## DEVELOPMENT APPLICATION ASSESSMENT REPORT

<b>Application Number:</b>	DA2023/0652
----------------------------	-------------

<b>Responsible Officer:</b>	Jordan Howard
<b>Land to be developed (Address):</b>	Lot 26 DP 236548, 4 Bellara Avenue NORTH NARRABEEN NSW 2101
<b>Proposed Development:</b>	Construction of a dwelling house
<b>Zoning:</b>	R2 Low Density Residential
<b>Development Permissible:</b>	Yes
<b>Existing Use Rights:</b>	No
<b>Consent Authority:</b>	Northern Beaches Council
<b>Land and Environment Court Action:</b>	No
<b>Owner:</b>	Sydney Water Corporation Ltd
<b>Applicant:</b>	Sydney Water Corporation Ltd

Figure 1 - Extract from Site Survey showing the sewerage easement burdening the property.

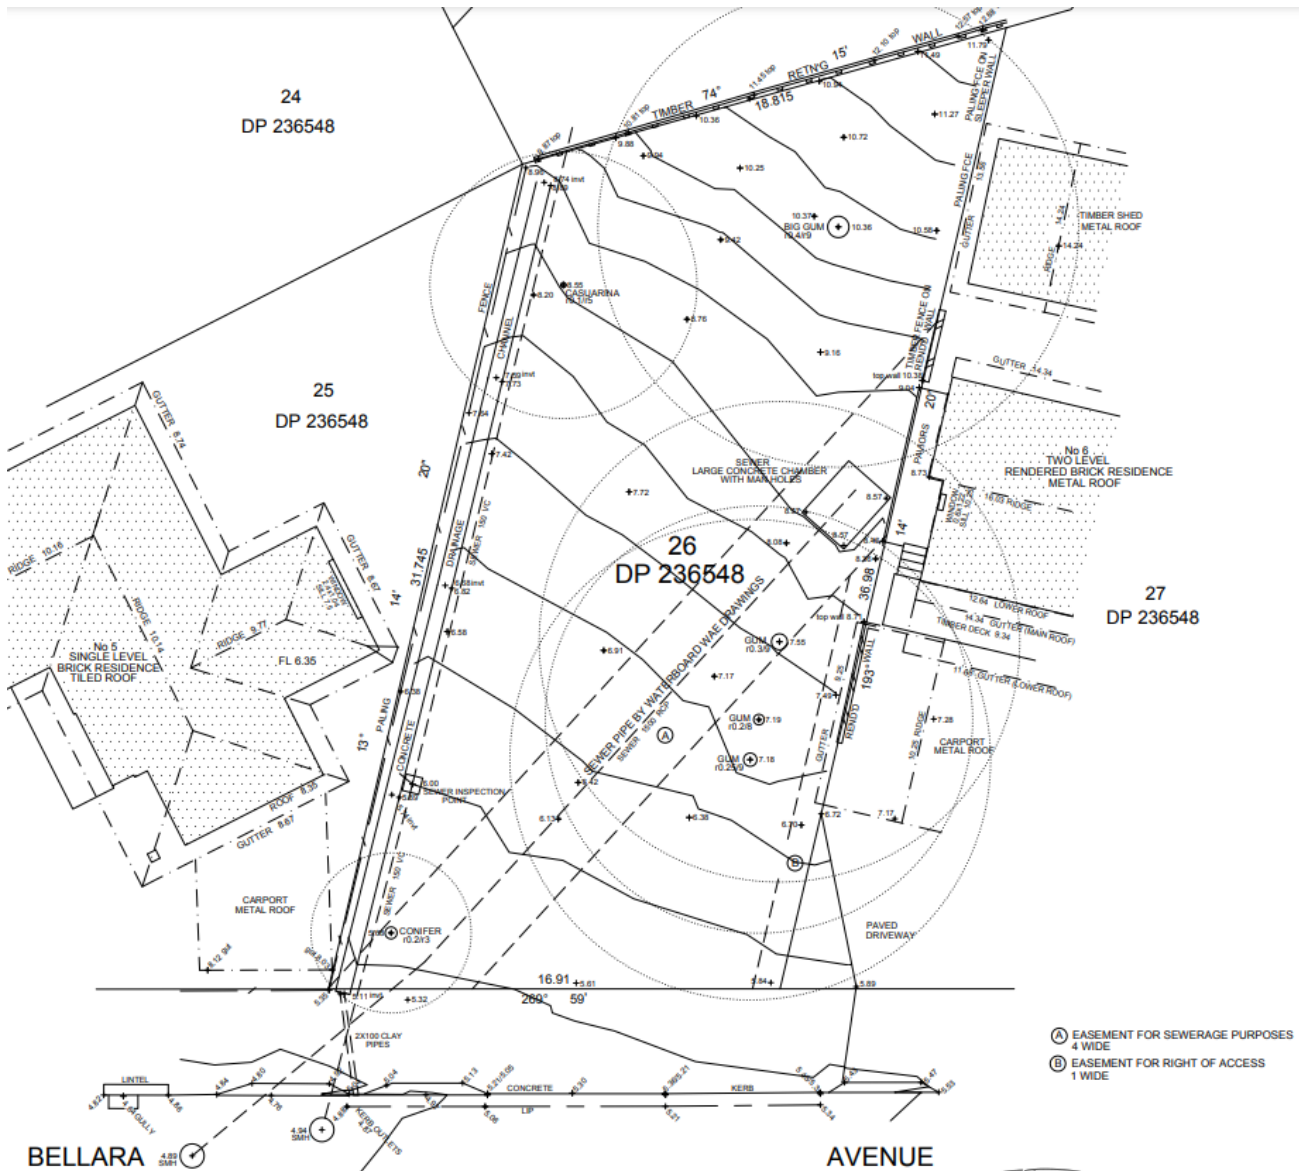
The proposal has a non-compliant rear setback of 3m, measured to the ground floor, representing a 53.8% variation to the required 6.5m rear setback. Measured from the first floor, this setback is 6m, representing a 7.7% variation.

It should be noted that the subject site is burdened by a sewerage easement, which cuts diagonally across the front half of the property (see *Figure 1*). This has the effect of limiting the buildable portion of the site to the rear, resulting in a larger than required front setback, and non-compliant rear setback.

Flexibility in the siting of buildings is considered appropriate in this instance given the constraints of the site, namely the sewerage easement at the front of the property.
